MODEL
2014~2016MY
Cadenza (VG)
2014~2015MY
Sorento (XMa)

NUMBER
148 (Rev 3, 8/31/2016)

TECHNICAL SERVICE BULLETIN

SUBJECT: CHATTER/RATTLE NOISE FROM ENGINE AFTER COLD SOAK

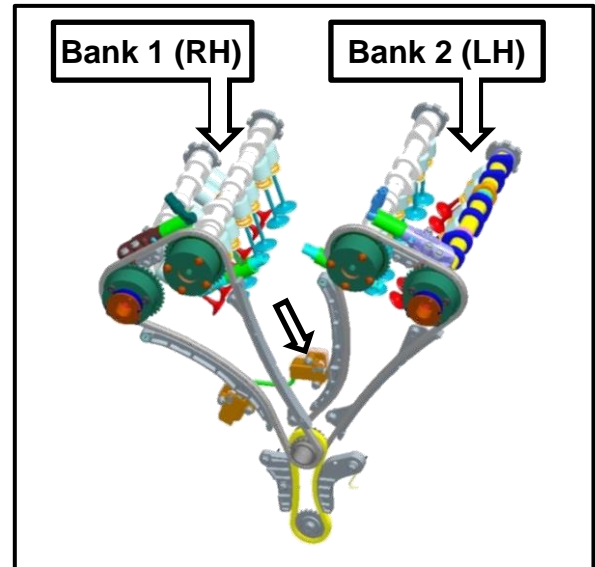
This Service procedure should ONLY be performed on engine bank 2 (LH), as shown.

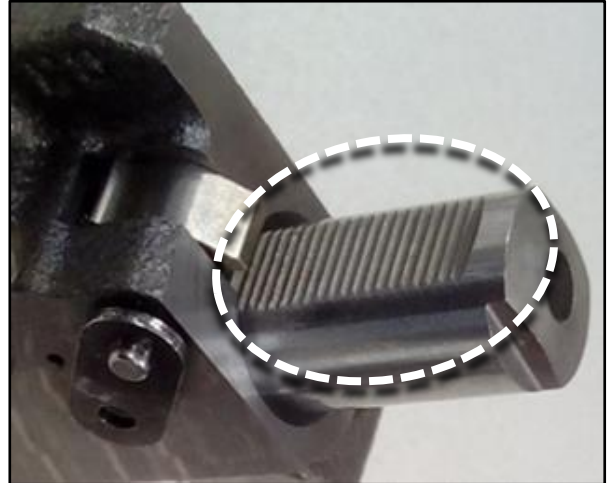
New tensioner design with finer pitch on teeth (1.5mm)

1. Refer to the “Engine Mechanical System → Timing System → Timing Chain” section in the applicable Workshop Manual on KGIS, to install the improved part.
2. Once proper tensioner installation has been completed, re-install all removed components by reversing the order of removal.
3. After confirming proper engine oil and coolant levels, start the engine and verify the rattle concern has been resolved.
